CITY PLANNING COMMISSION AGENDA

CPC PUZ 14-00055 – QUASI-JUDICIAL

CPC PUD 14-00056 – QUASI-JUDICIAL

PROJECT: CALVARY WORSHIP CENTER

Ph 1&2 Site Development Plan

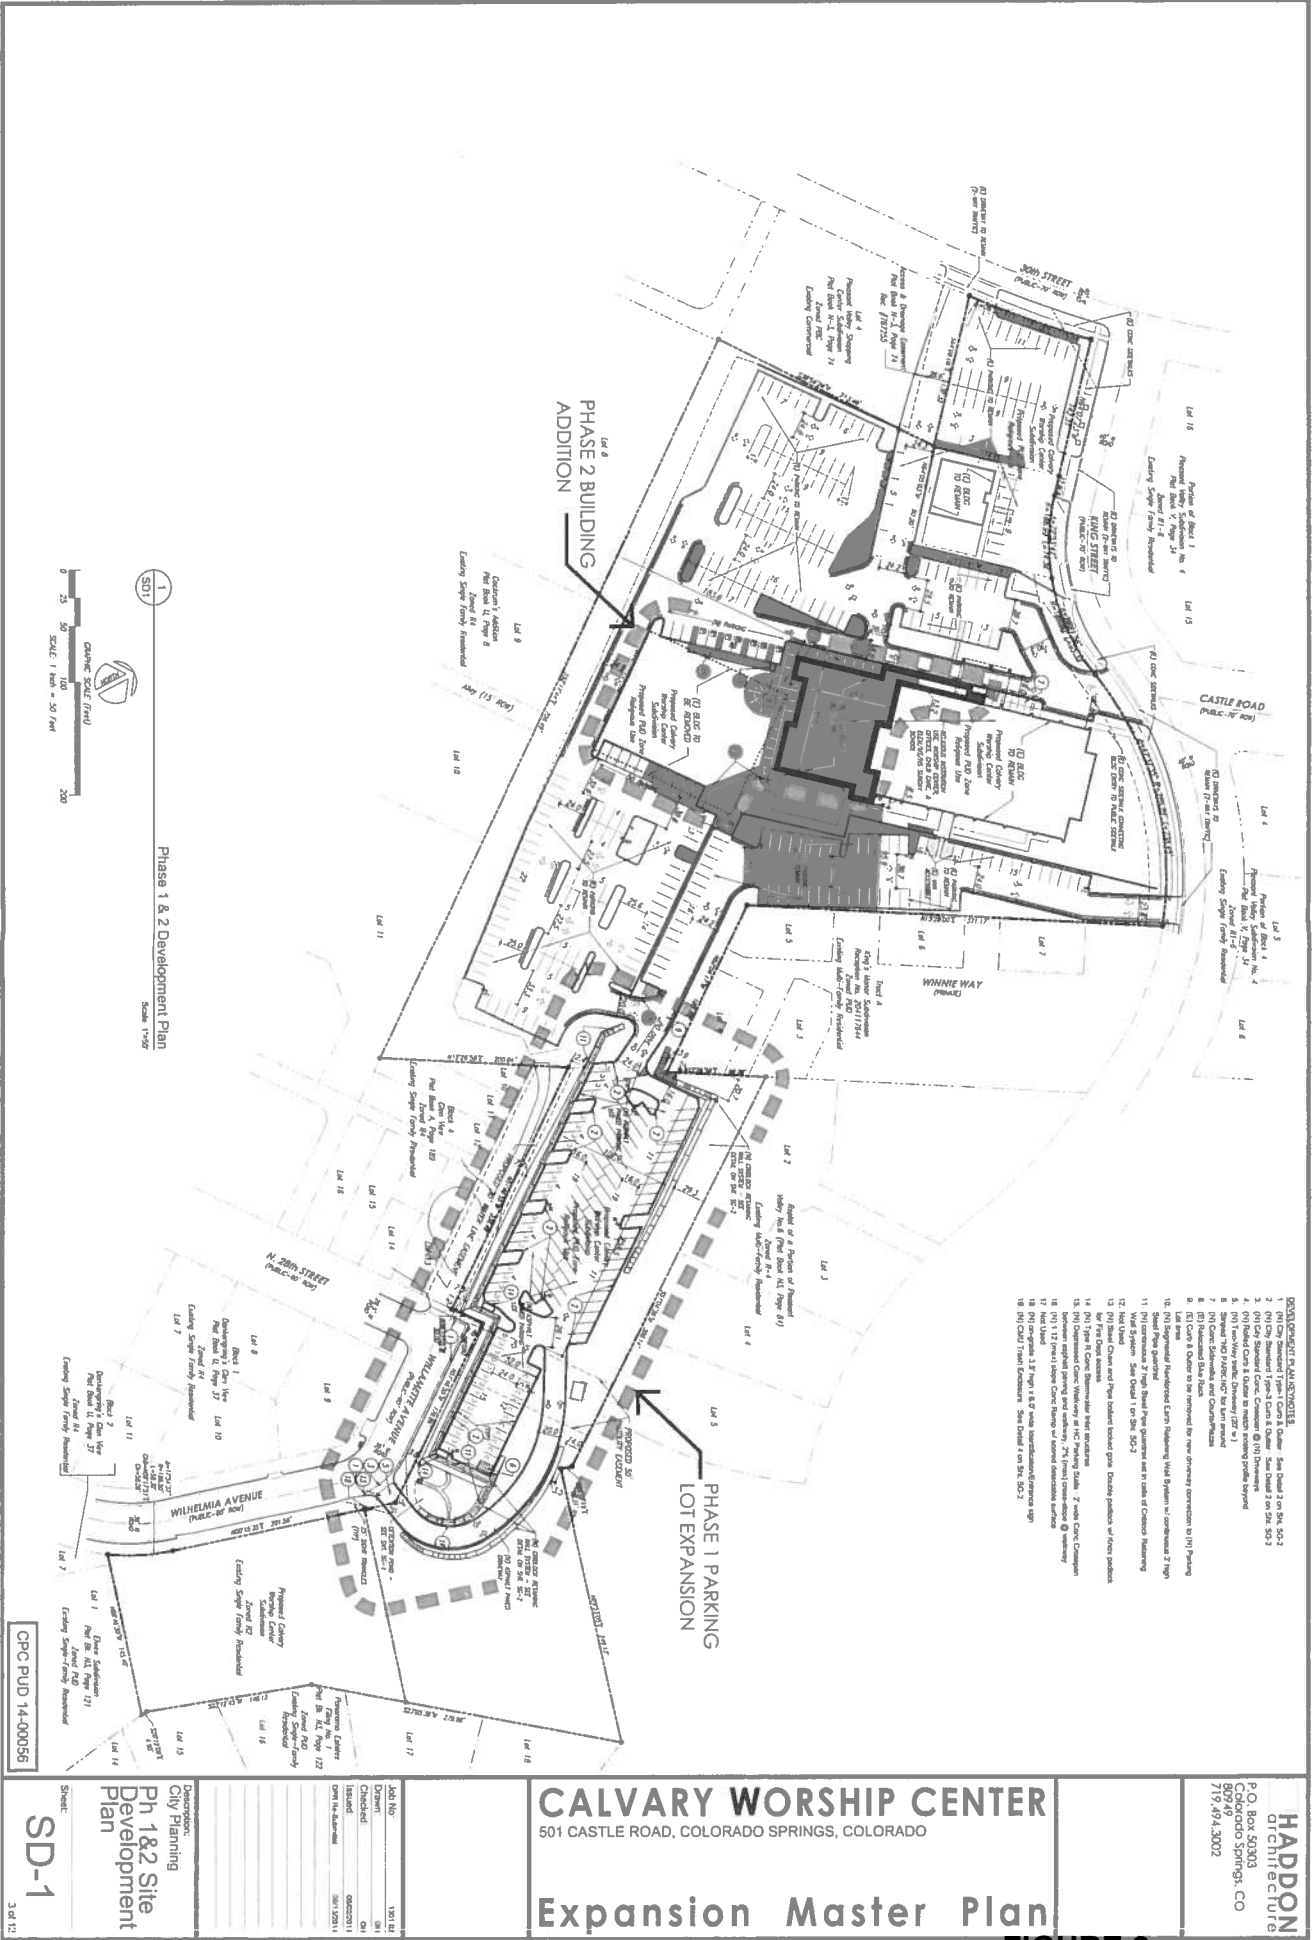
12. Ensure there is note clarifying when the Willamette Ave. access will be open; provide in both the notes section and on Sheet 3 (Note 13).
13. Correct the zoning as noted on the southeast parcel to remain R-2/cr (Two-family Residential with conditions of record).

<p>SD-2 4 of 12</p>	<p>City Planning Ph 3 Site Development Plan</p>	<p>CALVARY WORSHIP CENTER 501 CASTLE ROAD, COLORADO SPRINGS, COLORADO</p> <p>Expansion Master Plan</p>	<p>HADDON of Architecture P.O. Box 50303 Colorado Springs, CO 80909-943002</p>
--------------------------------	--	---	---

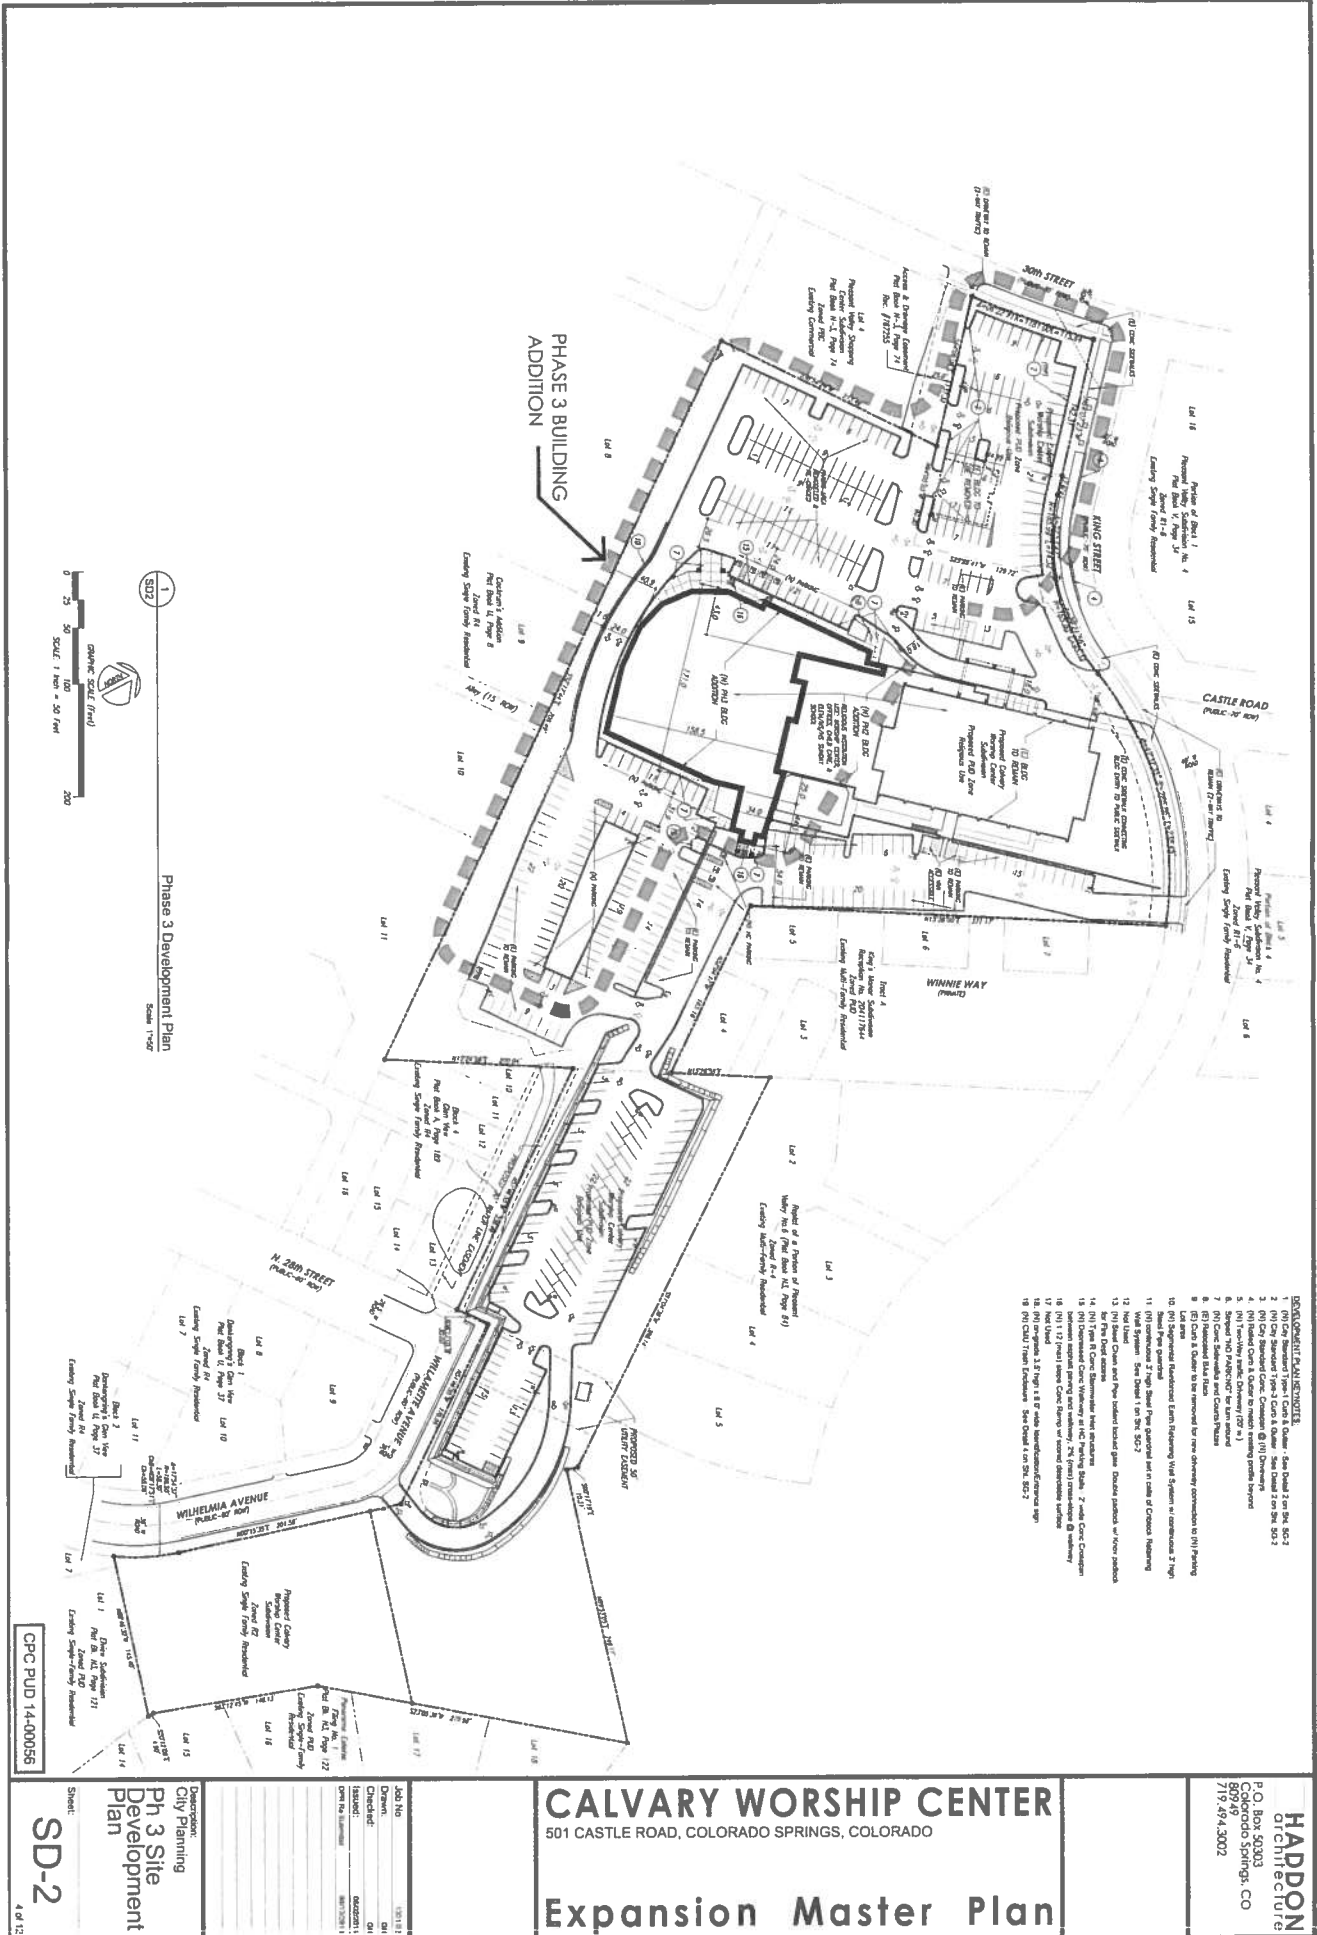
10. Ensure all compact stalls are labeled as part of Phase 3.
11. Ensure the parking counts on Sheet 4 (SD-2) are properly noted in each row of parking.

Slope Stability Analysis

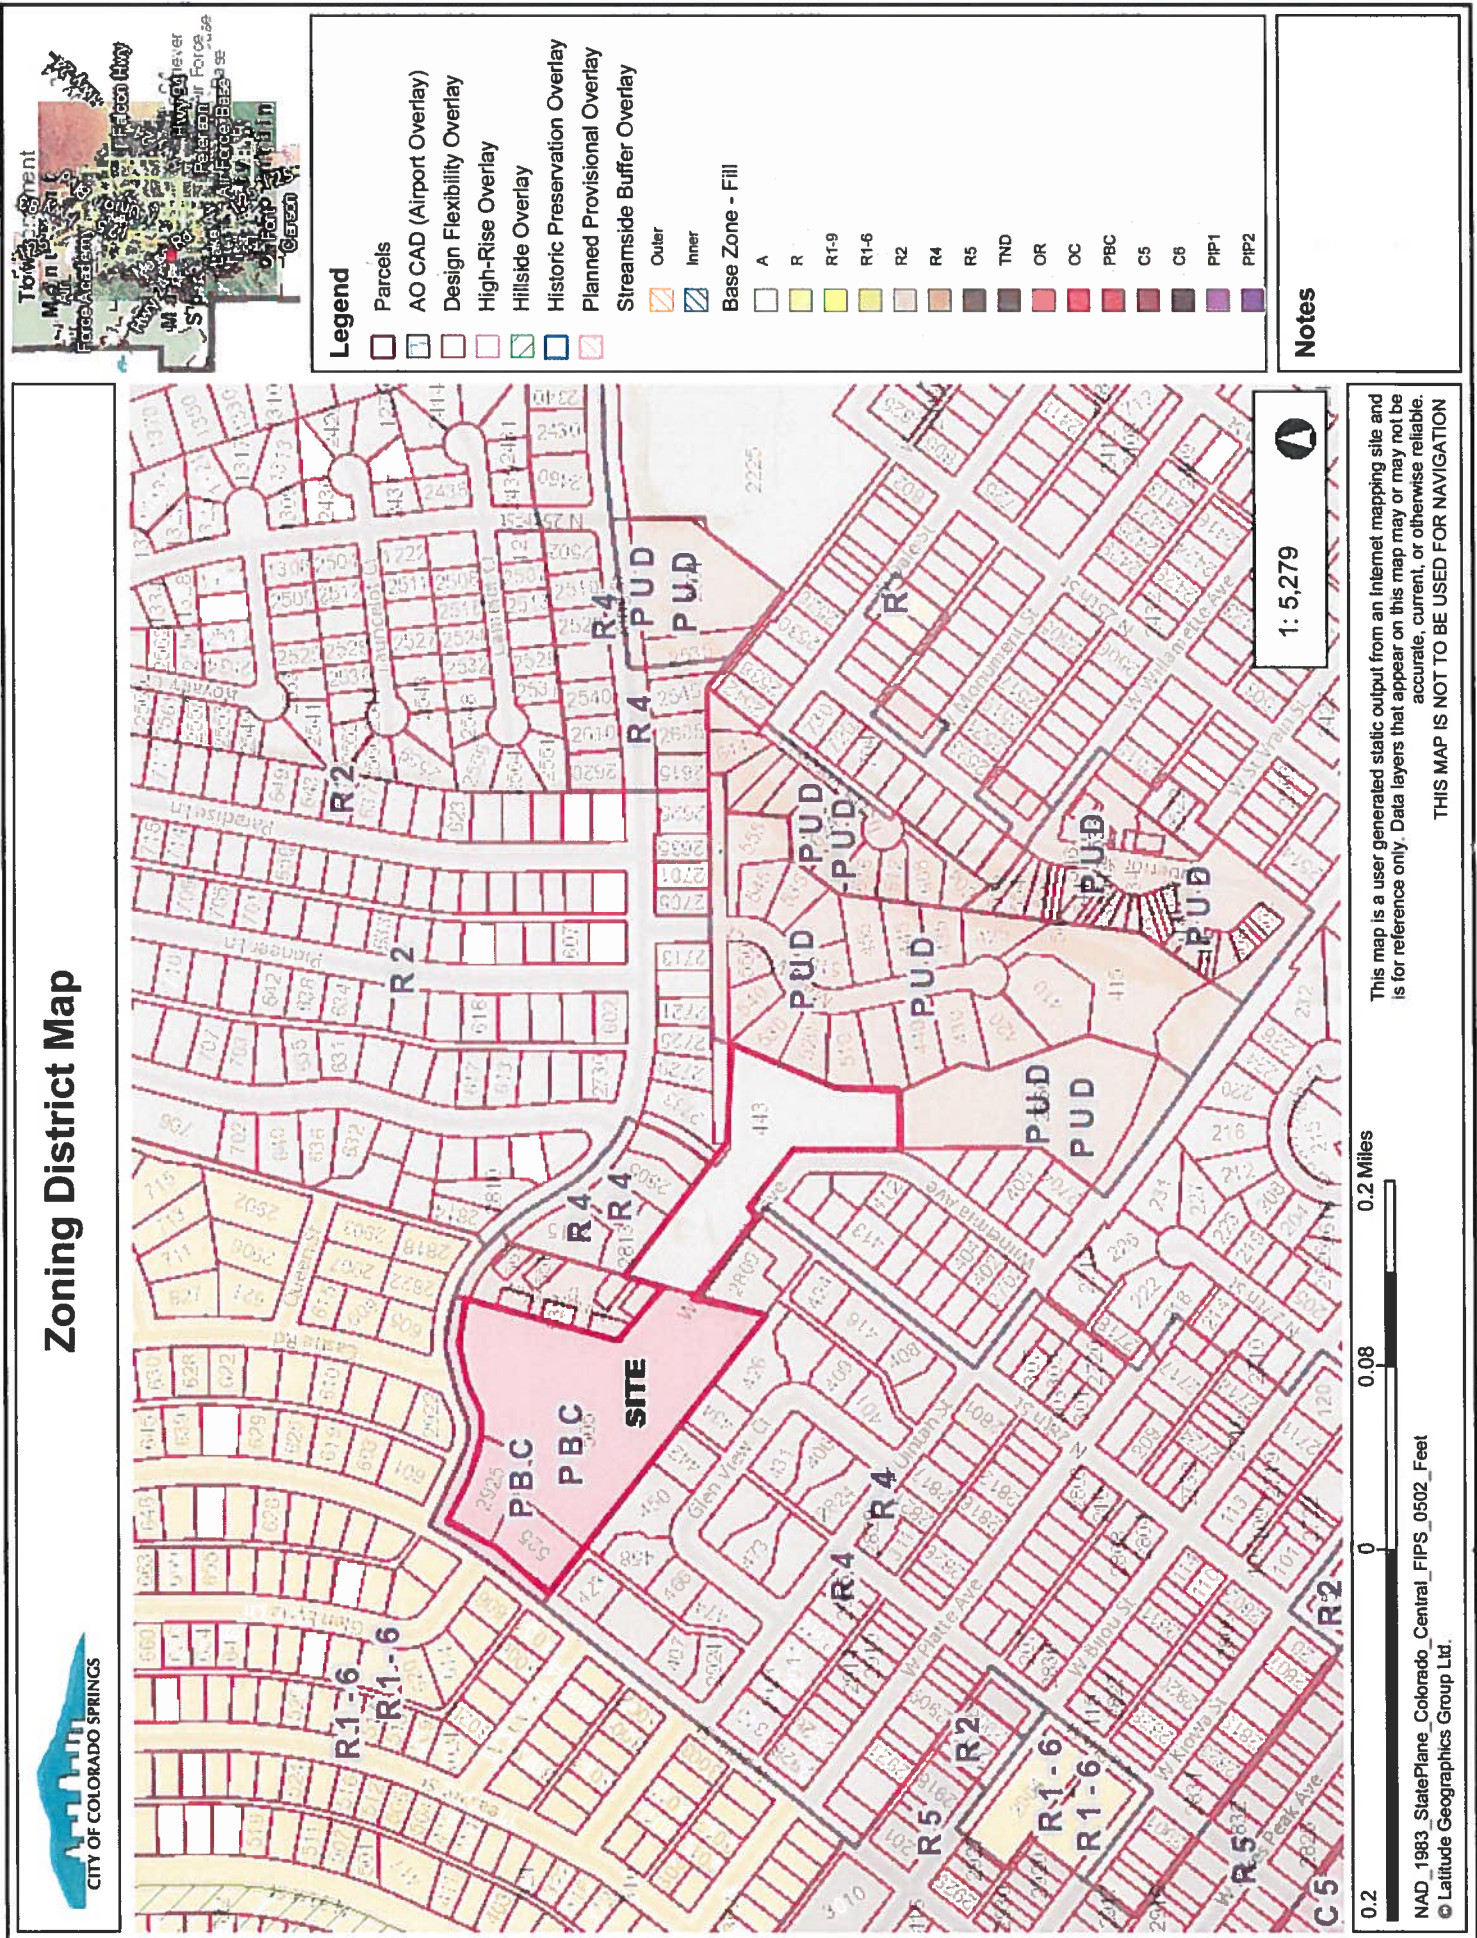
The applicant has provided a geologic hazard report regarding the slope issues involving the property as well as providing a slope stability analysis concerning potential slope impacts (**FIGURE 4**). The geologic hazard report and the development plan were forwarded to the Colorado Geologic Survey (CGS) for its review and comment. Jonathan White, the reviewing Senior Engineering Geologist, corresponded that CGS concurs with the RMG

FIGURE 6

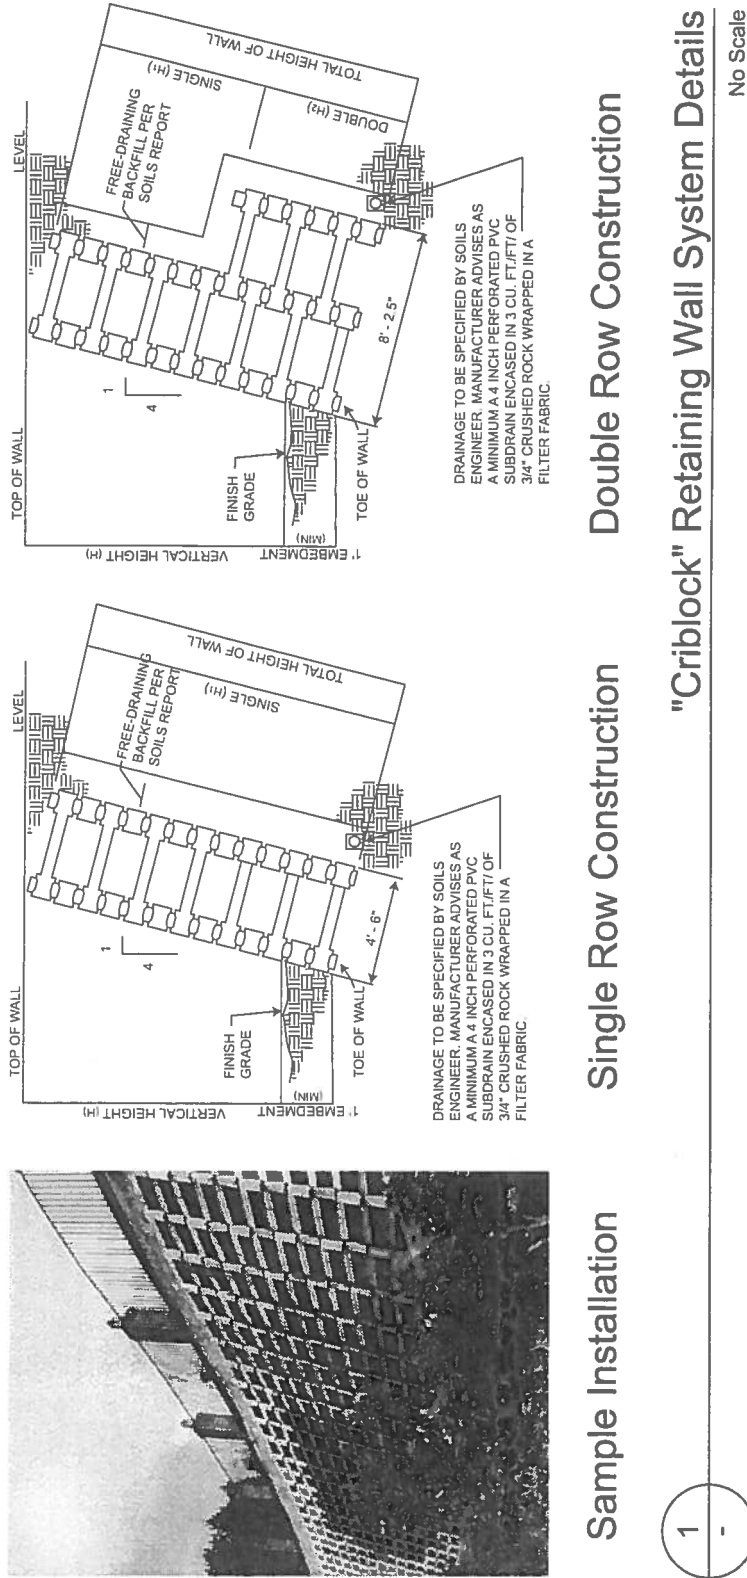
The applicant proposes to utilize a “crib lock” retaining wall system (**FIGURE 6**) both above and below the benched parking lot area in order to stabilize the slope above the parking lot as well as supporting the bearing load of the proposed parking lot. Due to the slope issues and overall height of the retaining walls, an engineered design is required to be reviewed when a building permit is requested for the series of retaining walls.

The crib-lock, wall cell, design has been a point of contention with several of the surrounding property owners who have indicated that the wall is too “industrial” in appearance and does not add aesthetic value to the neighborhood. Also at issue are the size of the retaining walls, which will range from five feet to almost 17 feet in height, that the neighbors feel are too imposing to the neighborhood. The tallest of the walls will be located along that portion of the site adjacent to Willamette Avenue.

FIGURE 7

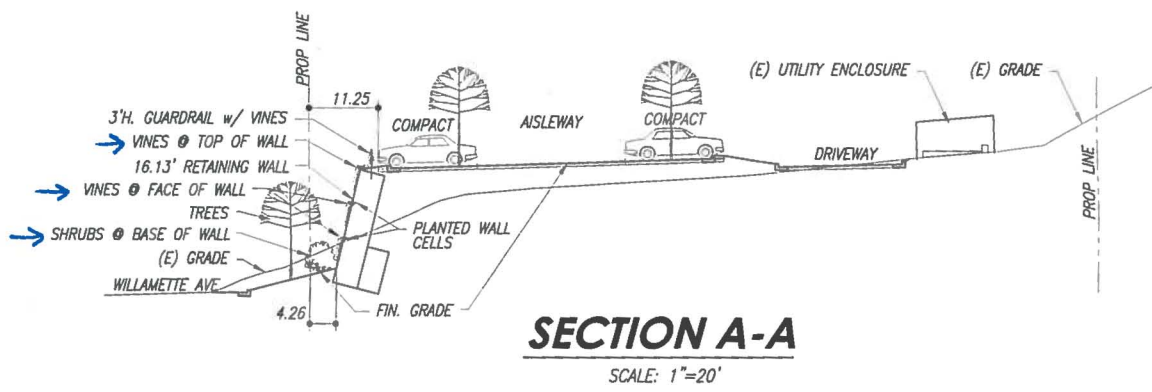
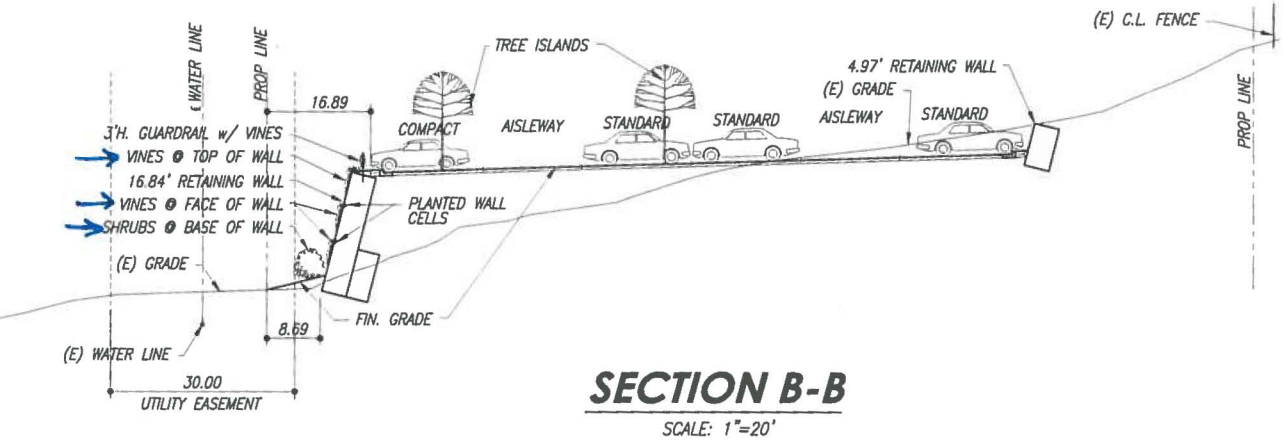
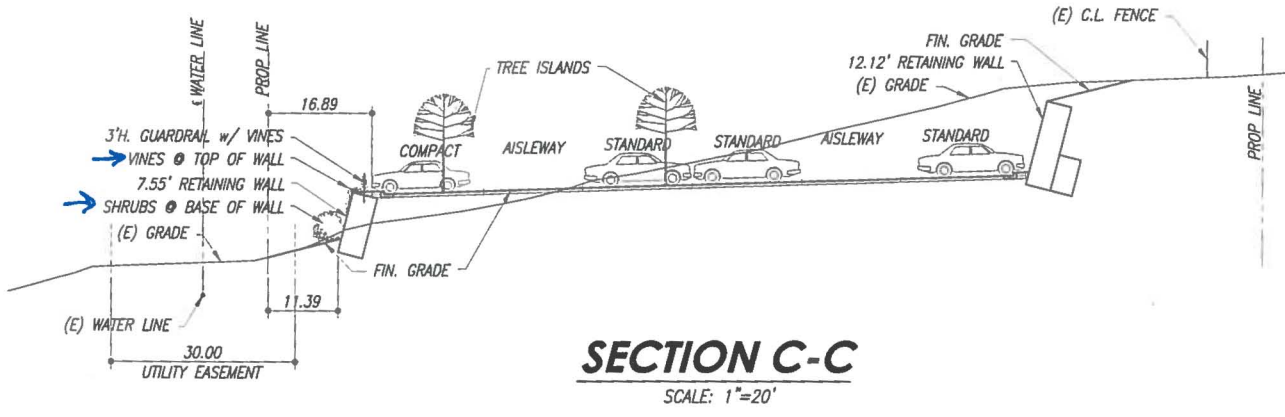
The applicant has contended that the crib-lock system is the most appropriate design since it will allow the wall to lie back against the slope to provide better slope stability. The wall also has an open cell design that allows vegetation growth to help break up the bulk and scale of the wall as well as moisture to freely flow in and out which may avoid freeze-thaw heaving issues. Staff has asked that a hearty vine species be used to help cover the wall; plantings are shown at the top, mid-section, and bottom to help facilitate a rapid coverage of the wall. (**FIGURE 7**)

Staff is requiring that vines be planted at the base, mid-level and atop of the wall in order to provide a vegetative screen of the wall; trees will also be planted atop the wall within landscape islands. Landscaping will be provided along Willamette and just above the parking lot to screen and buffer the wall and parking lot with adjacent properties.
